Office Action Summary

10/718,397

LOFLAND ET AL.

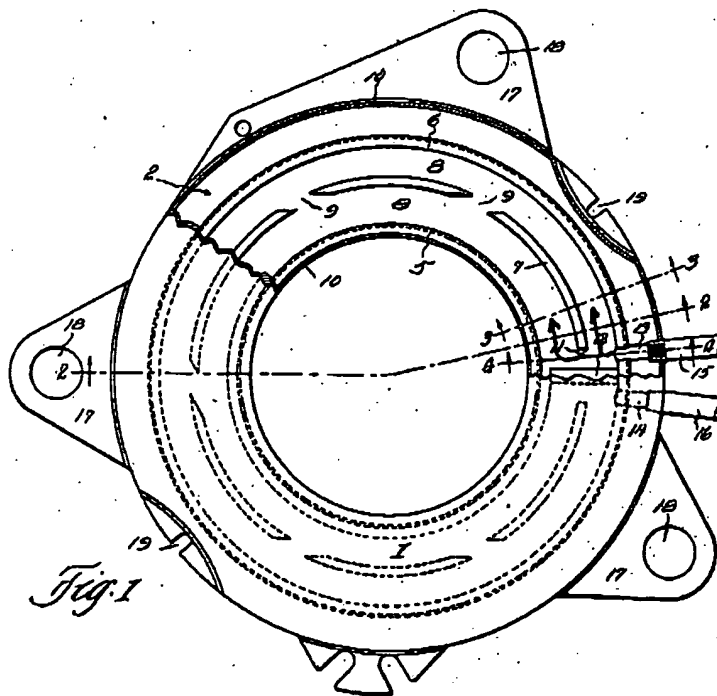
Claims 1 and 10 are rejected under 35 U.S.C. 102(b) as being clearly anticipated by Vandergrift. Vandergrift (Figure 2-5) discloses a first member 1 with semi-circular channel walls 3, 4 interlaced with a second member 2 with semi-circular channel walls 5, 6, 7 to provide two fluid flow paths having different directions (marked-up Figure 1 below).

The first fluid flow path from fluid inlet 13 turns immediately into the outer channel 8 proceeding until it turns immediately into the fluid outlet 14. The second fluid path extends radially inward or straight from the fluid inlet 13 and turn into the inner channel 8 beyond the semi-circular wall 7 proceeding until it turns immediately toward the fluid outlet beyond the semi-circular wall 7.

With respect to applicant's remarks in view of Vandergrift, the scope of the claim does not preclude the Examiner's reading of Vandergrift having "two fluid flow paths having different flow directions between the fluid inlet and fluid outlet." The claim does not recite the length of

the flow path or the relative directions of the flow paths. Therefore, the two fluid flow paths of Vandergrift, i.e. one flow path turning immediately into the outer channel from the fluid inlet 13 and the other flow path extending radially inward or straight from the fluid inlet and turning into the inner channel 8 are "different" flow directions "between the fluid inlet and fluid outlet." The Examiner agrees Vandergrift does not disclose opposite clockwise and counterclockwise directions, which is not recited in the claims.
